BULLETIN NUMBER:
SB13-04-S003A

SAFETY RECALL 13V-248

DRIVER DOOR SWITCH SHORT CIRCUIT

The service procedure has been revised. The procedure for applying the protective coating on the door module has been removed. Please discard previous bulletin SB13-04-S003.

Figure 1 – Driver Side Door Lock & Side Window Switch

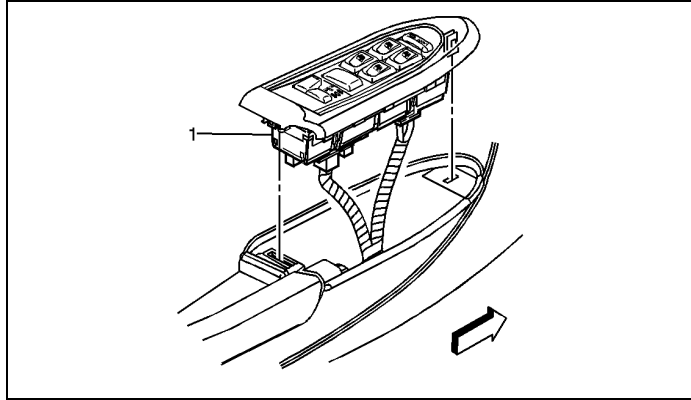
If fluid enters the driver's door module, it may cause corrosion that could result in a short in the circuit board. A short may cause the power door lock and power window switches to function intermittently or become inoperative. In rare cases, a short may cause overheating, which could melt components of the door module, producing odor, smoke, or a fire.

1. Remove the driver side door lock and side window switch. Refer to *Door Lock and Side Window Switch Replacement - Driver Side* in the service manual.

2. Determine the part number on the driver side door lock and side window switch. The part number is on the side of the switch on the label.
 - a) If the part number on the switch is listed in the parts table above, no repair is required. Re-install the driver side door lock and side window switch. Refer to *Door Lock and Side Window Switch Replacement – Driver Side* in the service manual, and then proceed to Step 3, “Applying the Campaign Label”.

- b) If the part number on the switch is NOT listed on the table above, replace the driver side door lock and side window switch. Refer to *Door Lock and Side Window Switch Replacement – Driver Side* in the service manual.
